71-9239

Your ref: Docket No. 71-9239
Our ref: LCPT-08-1

SUBJECT: Docket 71-9239, Model Nos. MCC-3, 4, 5 Packages, Approval for Shipment of Modified Fuel Assembly Contents

Figure 1: Fuel Assembly Orientation (from Top & Bottom View Perspective)

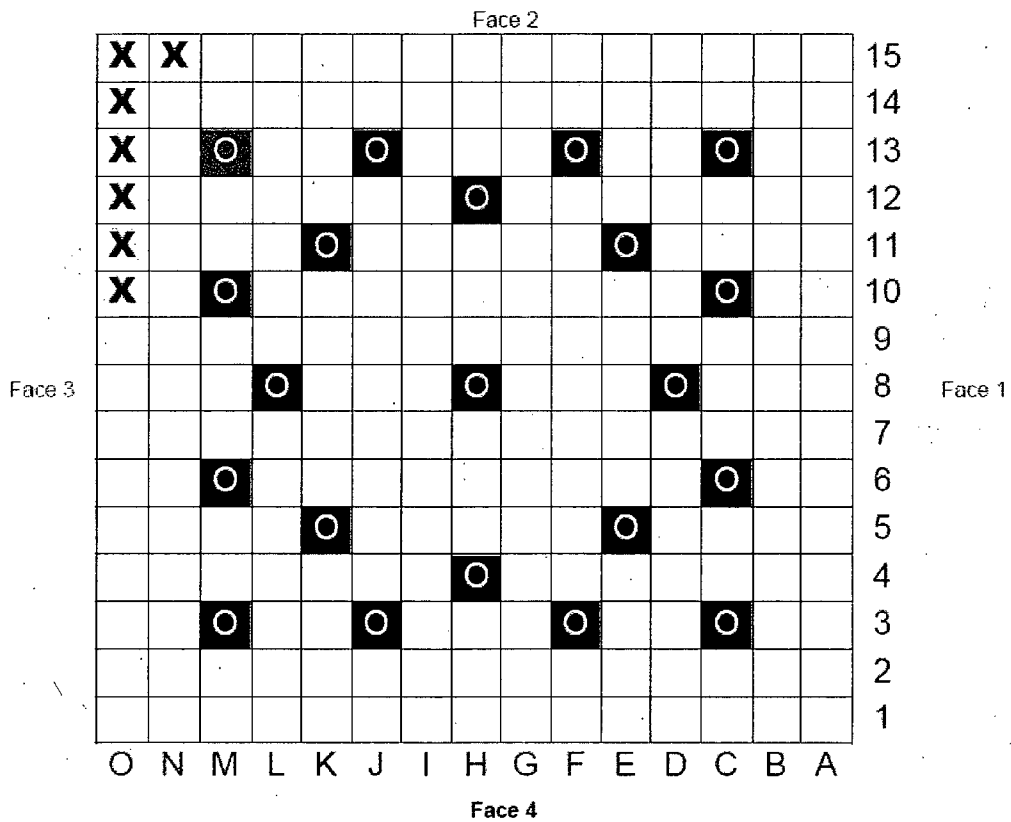
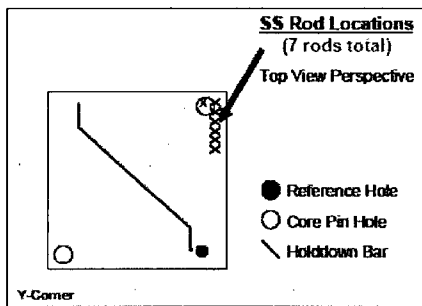
In accordance with Subpart D-Application for Package Approval, 10 CFR 71.31, Contents of application, Westinghouse Electric Company hereby submits an application for modification of the authorized contents as specified in existing Certificate of Compliance number 9239. This request is for authorization for a one-time shipment of a 15X15 (Type B) OFA fuel assembly that is modified by replacing fuel rods in locations O10 through O15 and N15 with solid stainless steel rods (see Figure 1).

-  Thimble tube location
-  Stainless steel rod location

Figure 1 Plot of 15x15OFA Uncontained Assembly

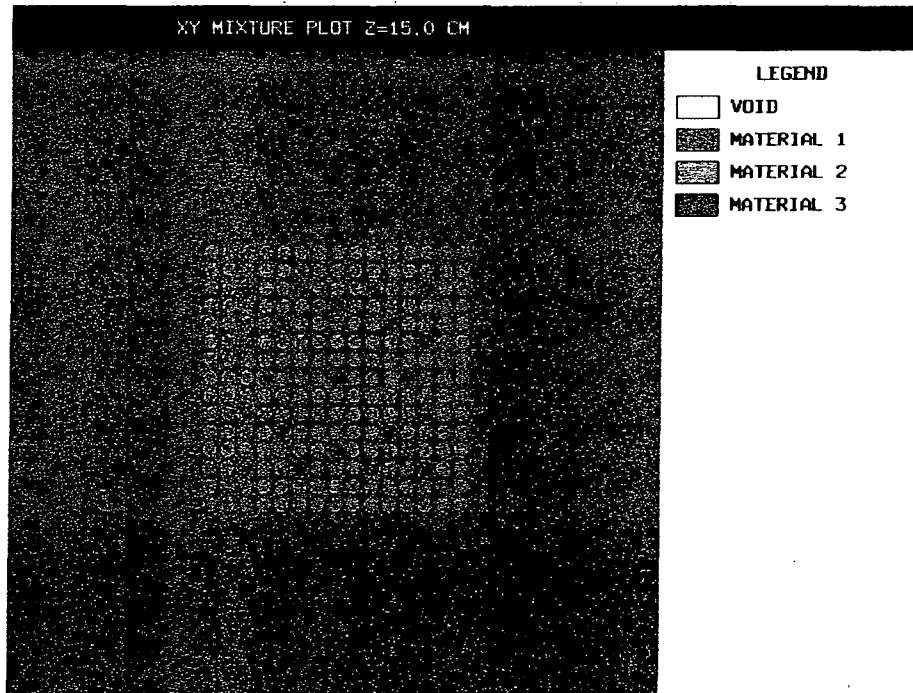
The current calculation methodology is SCALE 4.4 CSAS25 using the 44-group cross-sections. The 15X15 (Type B) OFA result reported in Table 6-2-1 of the application is validated using the current calculation method, and the relative difference of less than 0.01% is acceptable. Evaluation of the modified 15X15 (Type B) OFA with 7 stainless steel rods demonstrates that the reactivity of the fuel assembly is less than that for the 15X15 (Type B) OFA used for the evaluation in the application.
